Final Plat
SUBDIVISION REPORT

S/D No.: 87-54 Name: THE MOORINGS 4TH ADDITION

FINAL PLAT

THE MOORINGS 4TH ADDITION

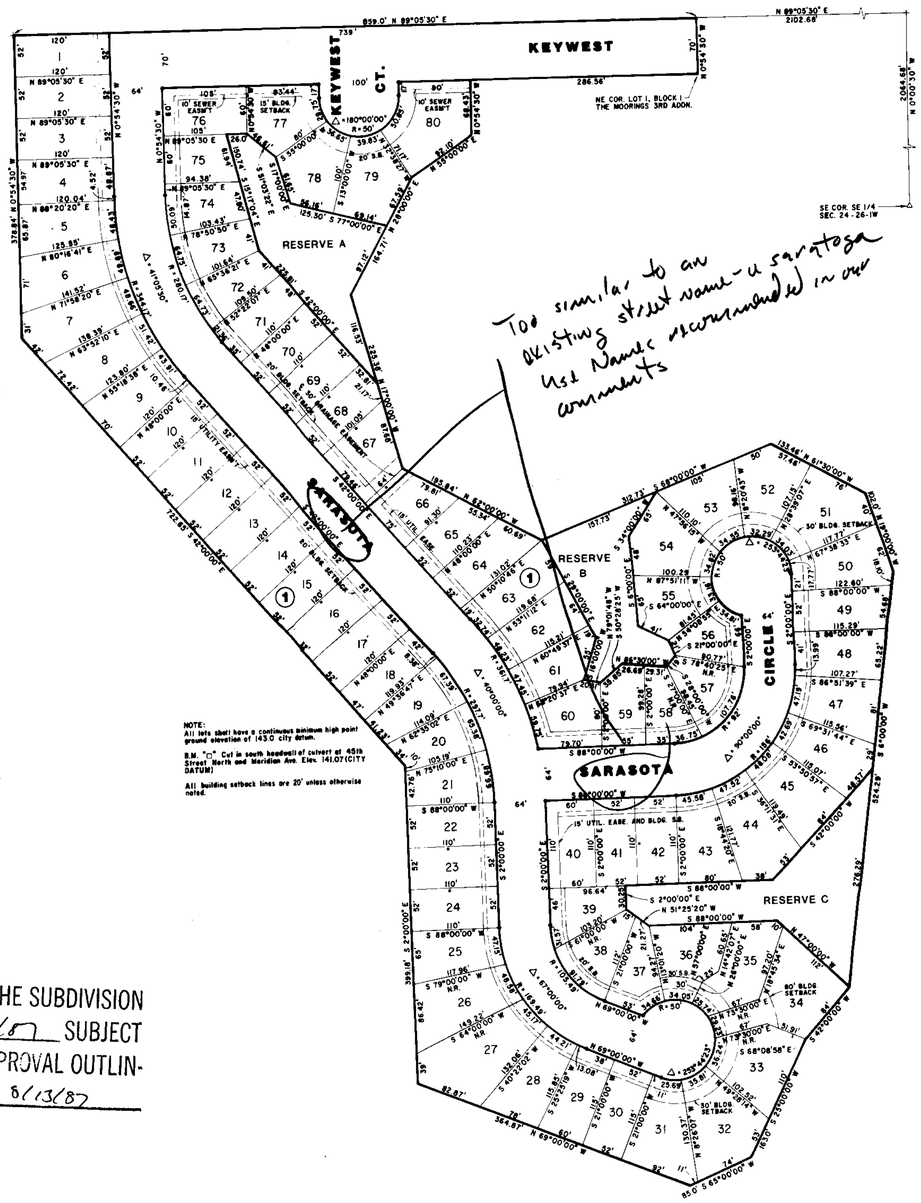
K. On the final plat tracing, the street names Sarasota and Sarasota Circle shall not be used. For emergency services, this name is too similar to the existing street name of Saratoga. As indicated at the time of preliminary plat approval, the use of the names "Siesta Key Circle" and "Siesta Cove Circle" are acceptable.

I. On the final plat tracing, the plattor's text shall be amended to include reference to the minimum building pad elevation.

Too similar to an existing street name - a saratoga list Names recommended in our comments

Somewhat strange how bearings are stated in text versus how they appear around plat - a N-S-E-W are reversed, depending on how they appear.

Need to indicate min. bldg. pad. elev. on lot.

a lot owner's or homeowner's
